SANITARY SEWER IMPROVEMENTS

PIKE ADDITION

CITY OF WICHITA, KANSAS

B. Woods - City of Wichita, Field Project Engineer
 Final Acceptance Date: 8/13/2021
 Completion Date: As-built
 : apr 4/21/2022

PIKE ADDITION
FORCE MAIN
 PUMP STATION AND FORCE MAIN

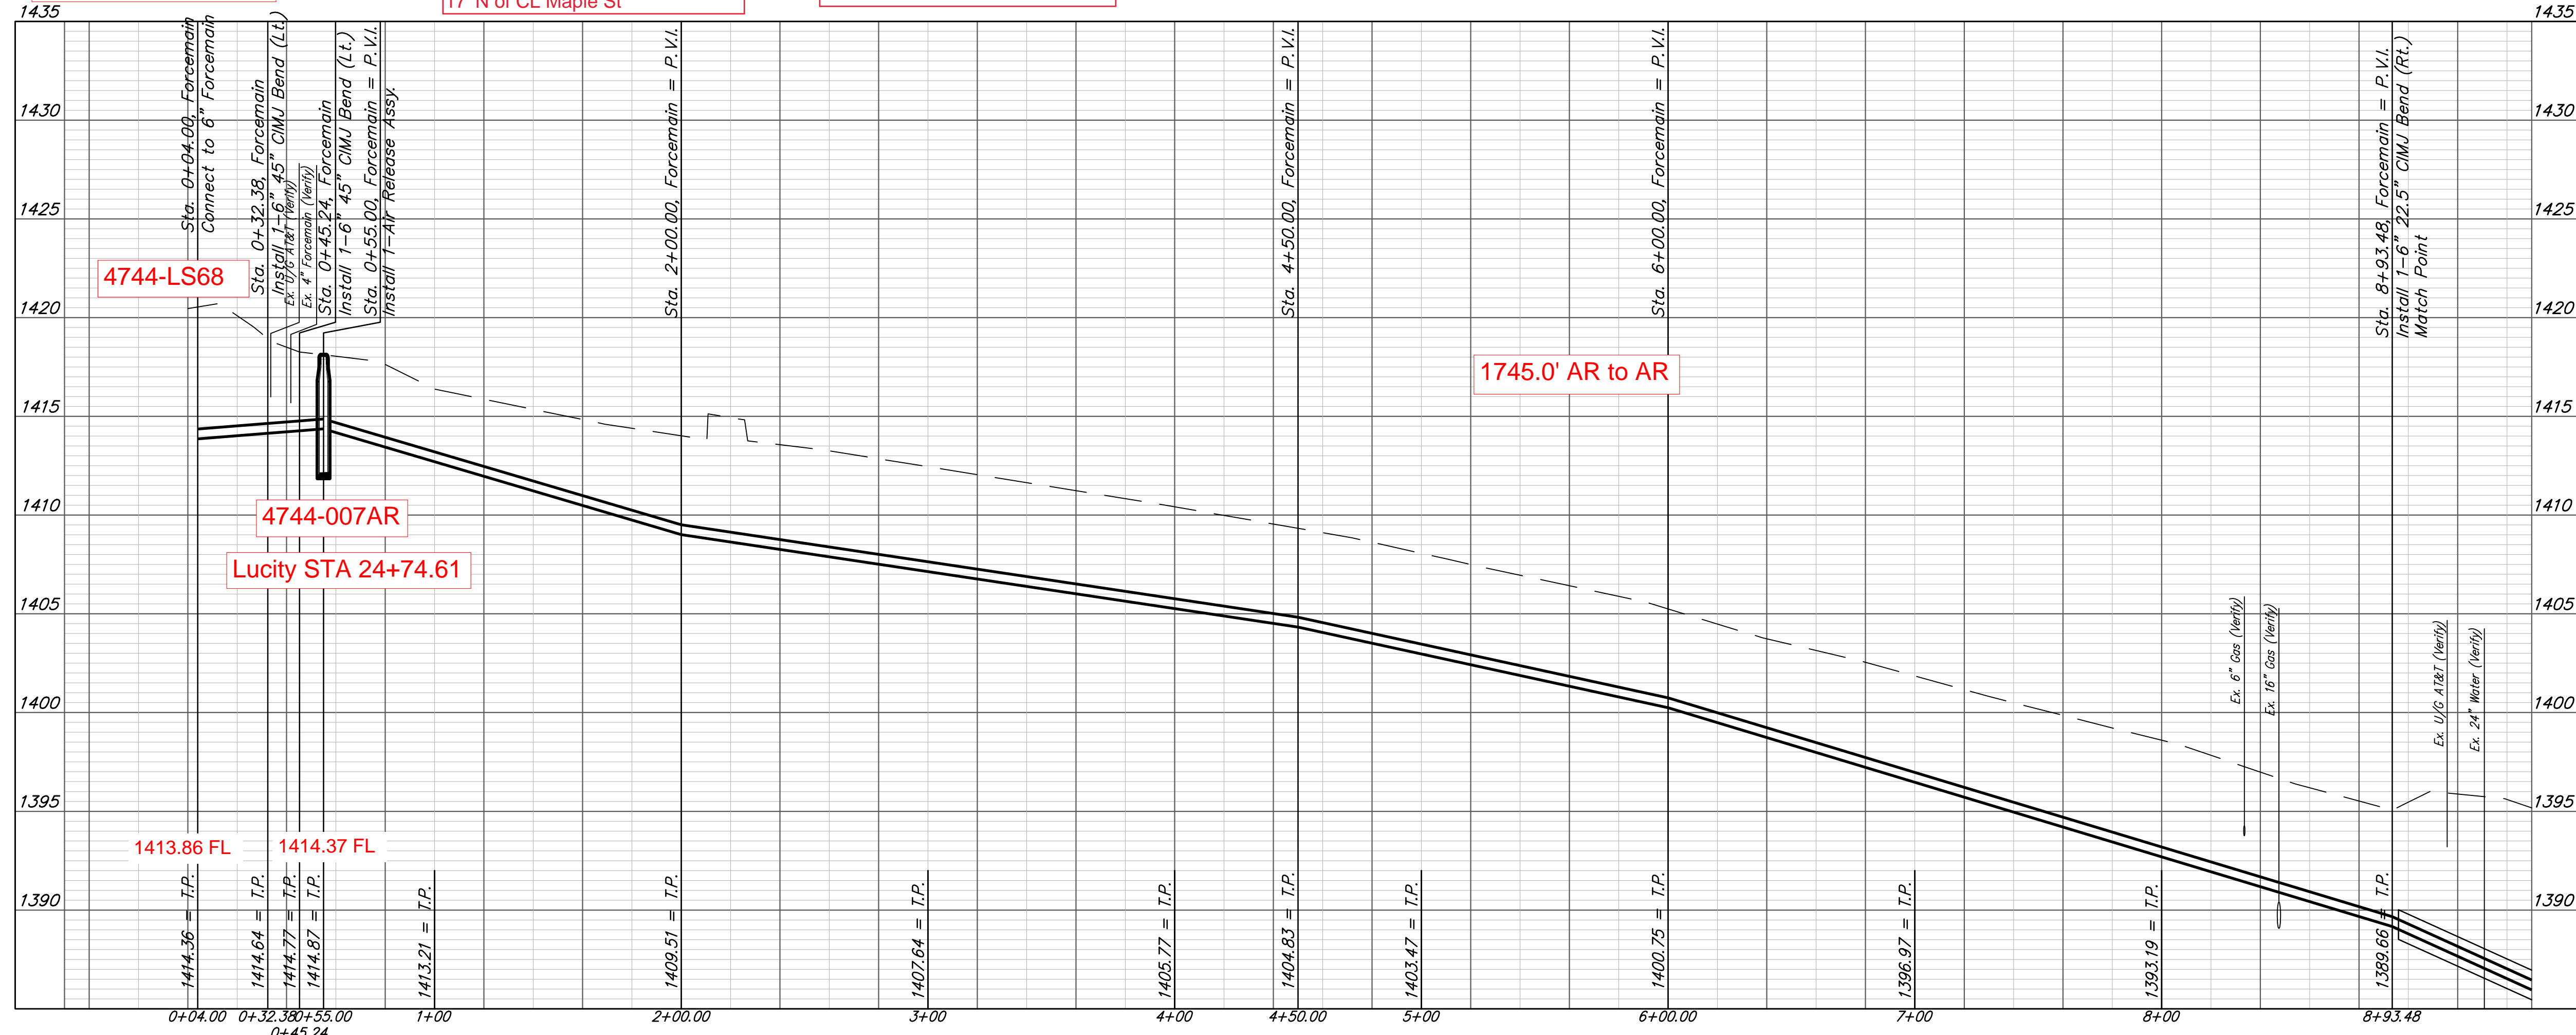
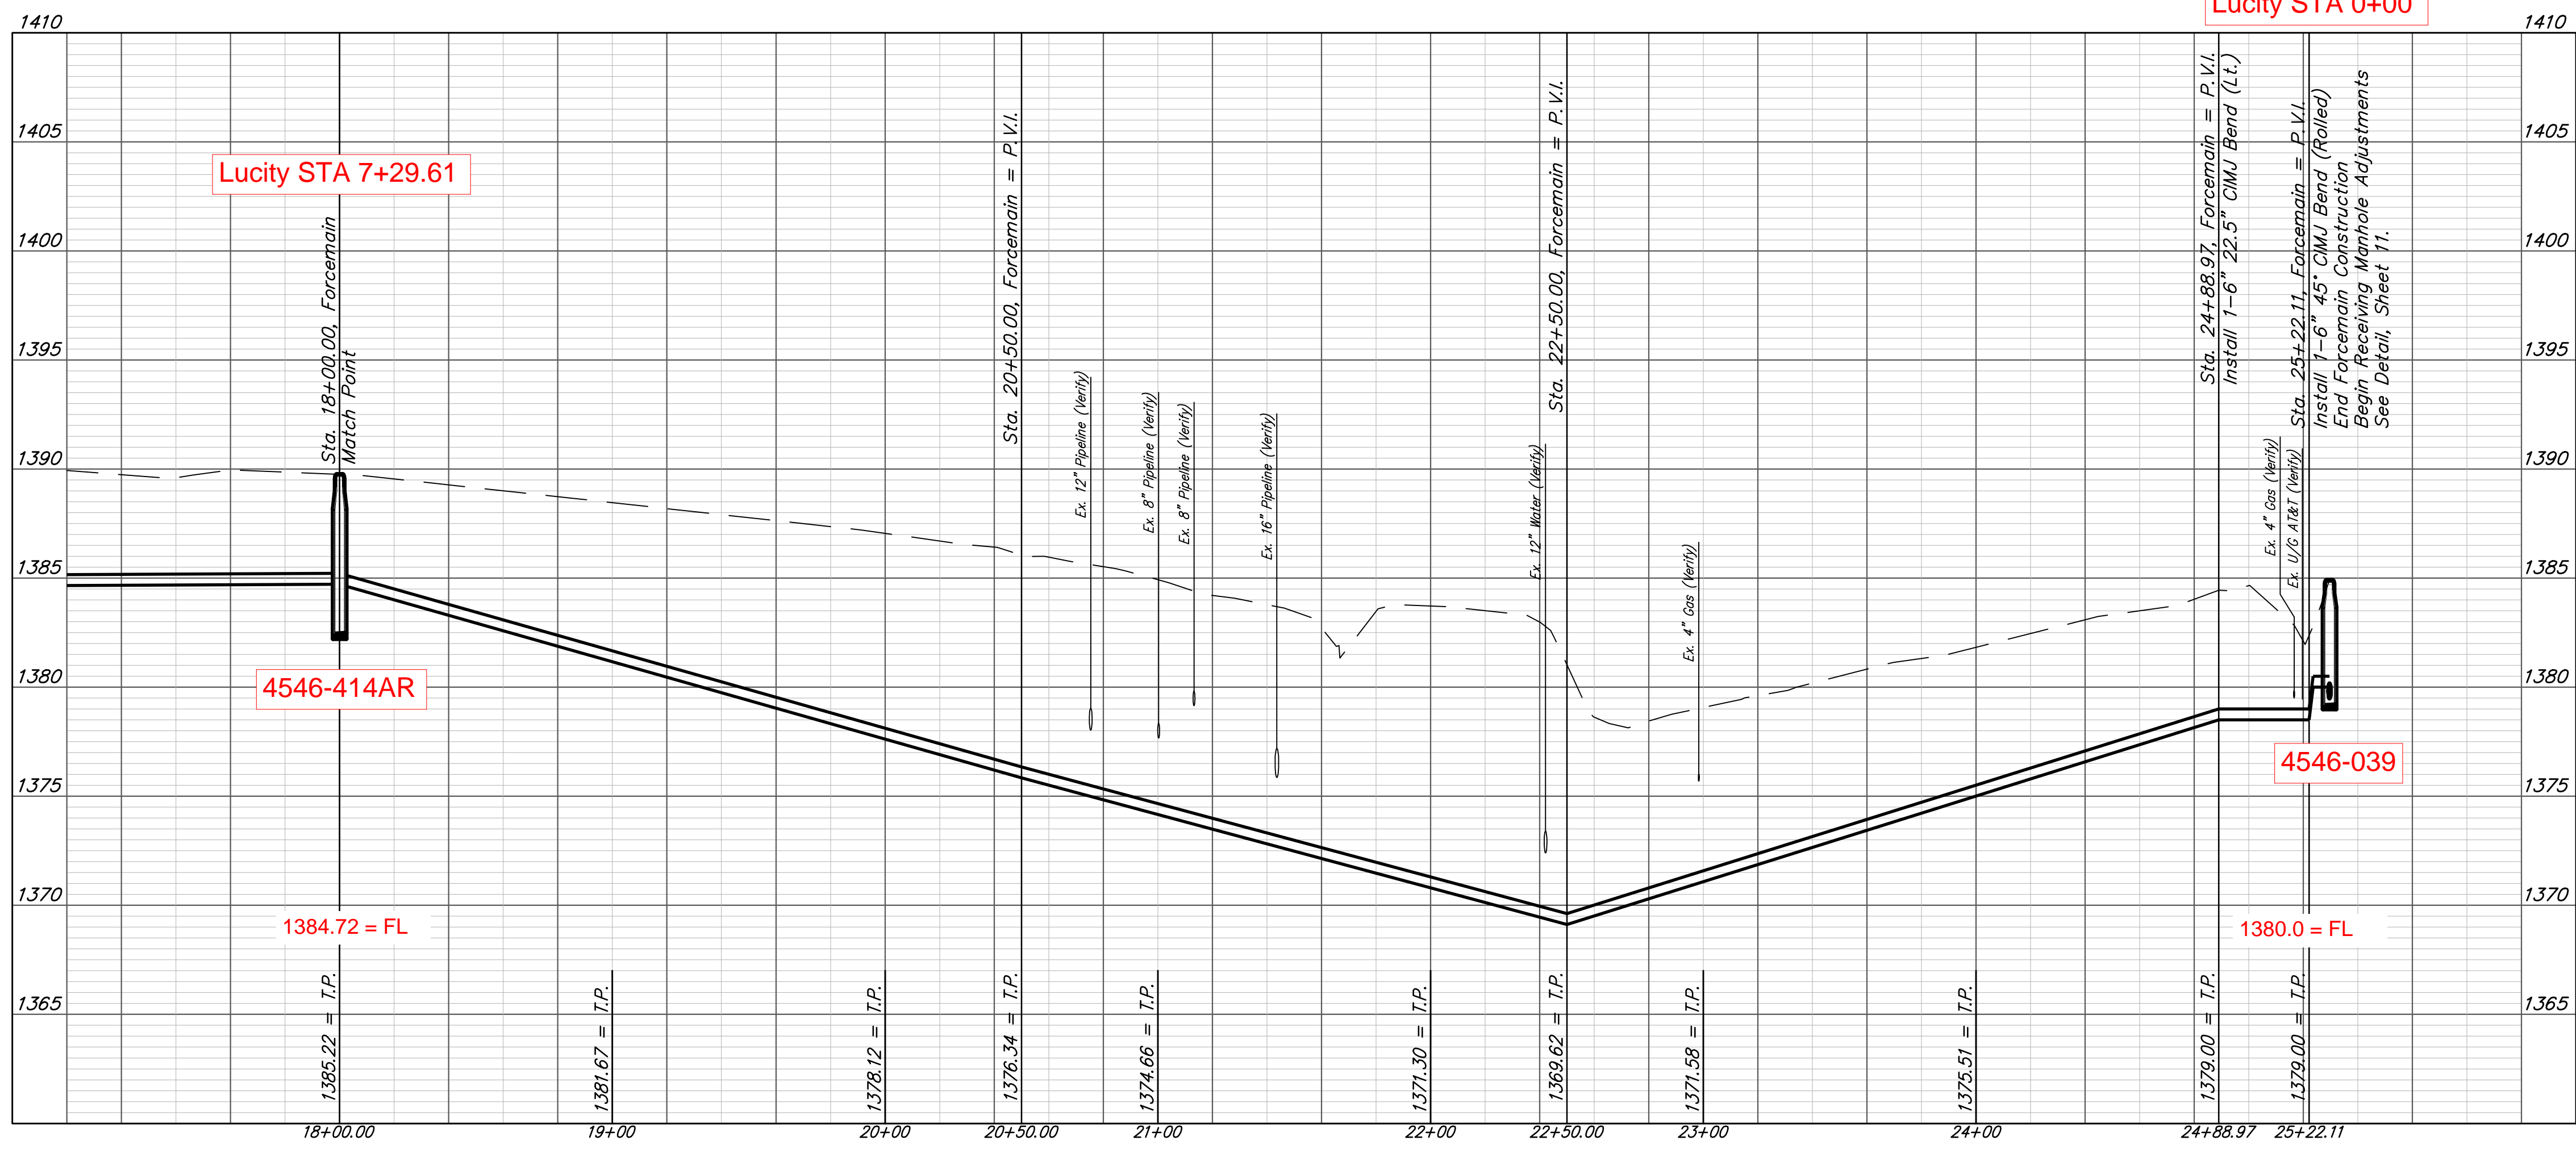
Stationing is backwards for our data

22 Bend
 72' W of CL 151 St
 17' N of CL Maple St.

45 Bend
 53" E of CL Driveway of lift station.
 27' N of CL Maple St

45 Bend
 62' E of CL driveway of lift station
 17' N of CL Maple St

Air Release
 72' E of CL driveway lift station
 17' N of CL Maple St

Lucity STA 25+29.61

Lucity STA 24+74.61
